No.	2022-P129
To	Board of Directors
Date	2022-10-04

Federal Land Use and Design Approval – Parliamentary Precinct – Centre Block Rehabilitation Program and Parliament Welcome Centre – 100% Schematic Design

RE: FLUDTA REVIEW – CENTRE BLOCK REHABILITATION PROGRAM (CBRP) 100% SCHEMATIC DESIGN SUBMISSION

Schematic Design Rendering of new Central Entrance, April 2022

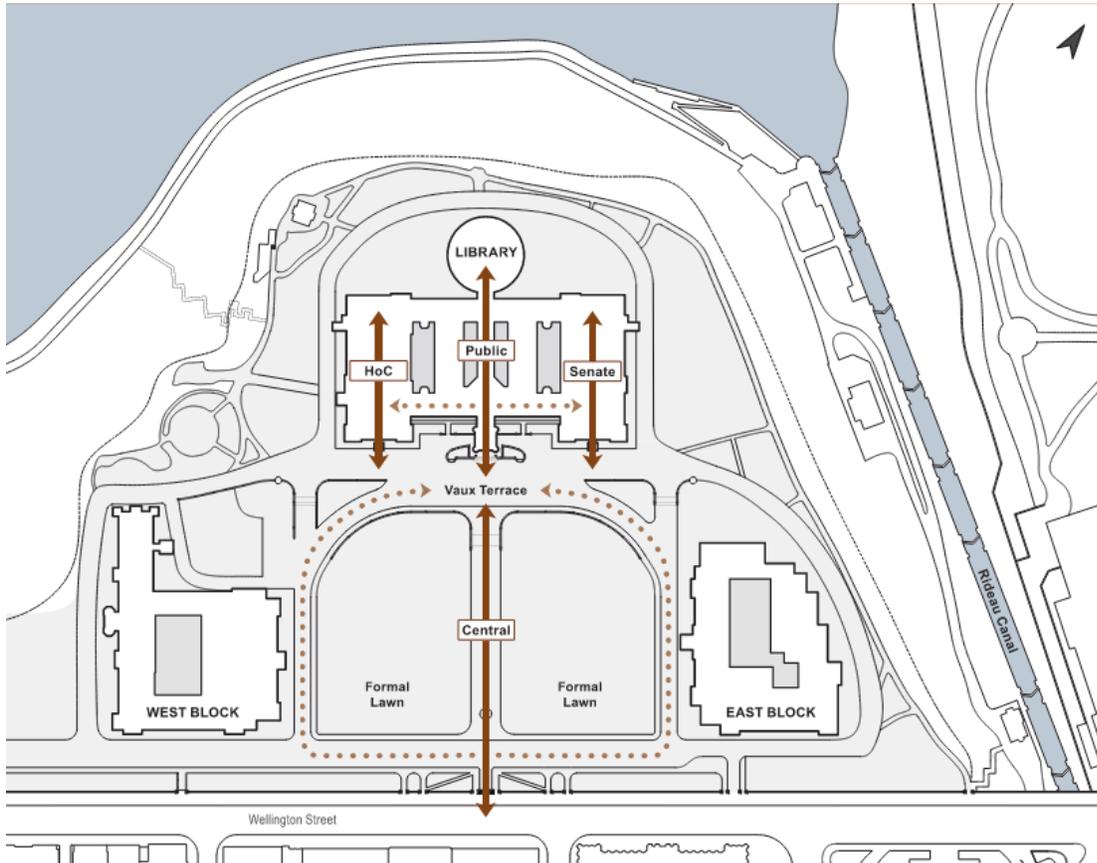
- 2.2. The design development of the entrances into the below-grade PWC (on both sides of the Vaux stairs) should be informed by, and compatible with the approach to Phase 1 of the Visitor Welcome Centre Complex (VWCC). More specifically, as it relates to the design of the entry arches and the incorporation of new stonework into the heritage Vaux Wall.

- 2.4. The intuitiveness and clarity of the Enhanced Entry Sequence should continue to be developed, such that reliance on wayfinding can be minimized as much as possible. For example, if the intention is for users to enter to the left of the Vaux stairs, and exit on the right side, how will this be obvious without relying on signage?
- 2.5. While it is understood that grading revisions to the formal lawn are required to accommodate a universally accessible central entrance, the design of the forecourt should maximize the amount of space that is flat to gently-sloped and suitable for the traditional uses of the Parliamentary lawn (celebration, gathering, protest, events, etc.).

Parliament Welcome Centre Level B1 floor plan with new entry sequence.

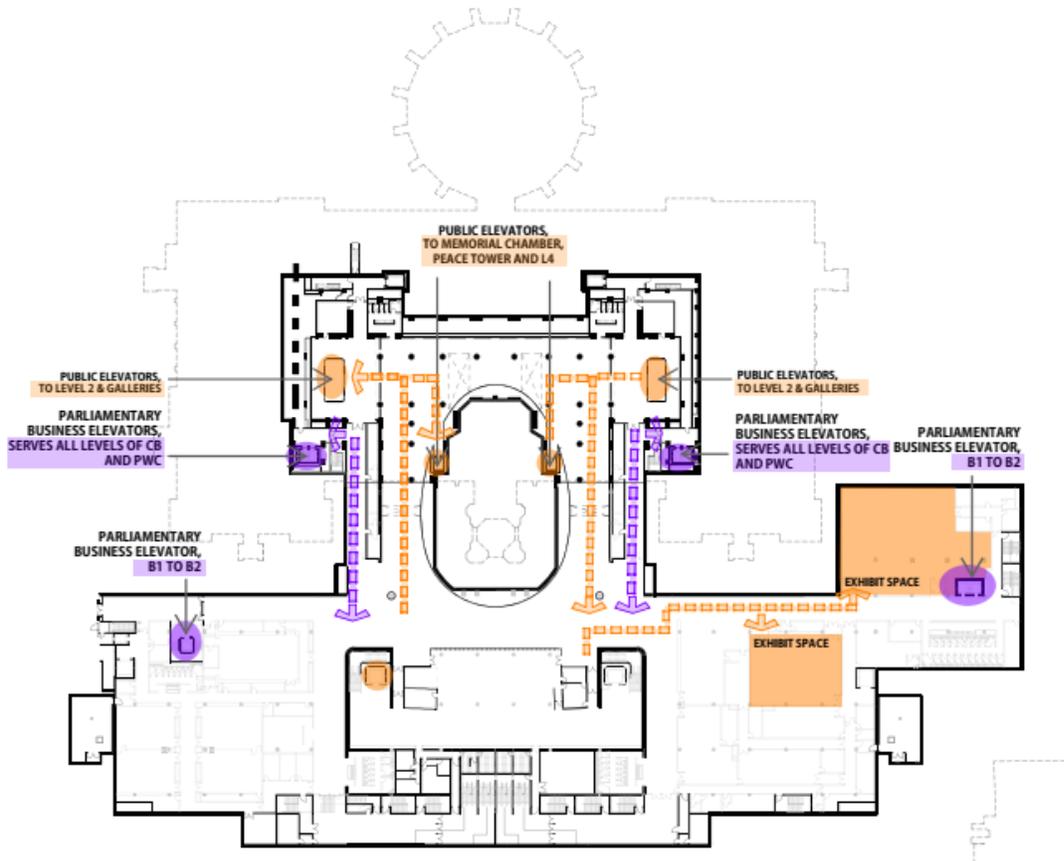
- 3.3. The treatment of the interior of the PWC – including the pattern and scale of interior finishes, finish materials, skylight detailing, and ceiling design at Level B1 – should be further developed in the next design phase. Particularly, the proponent team should develop a decorative program that is on par with the rich details of the existing Centre Block. Proposed details should speak to the craftsmanship, symbolism, and quality present in the original building without trying to replicate it. For example, consider collaborating with the Dominion Sculptor for ways to integrate artwork into new masonry work.

- 3.4. There seems to be little connection between the ovoid shape at the centre of Level B1 and the existing Centre Block / Peace Tower foundation at the present stage of design. Clear design vision is required to justify the ovoid shape and explain its relationship to the existing Centre Block. Until then, it remains difficult to evaluate this element of the design.

- 3.5. Similarly, the material treatment of the curved wall of the ovoid form will be an important component for evaluation in the next phase of design.
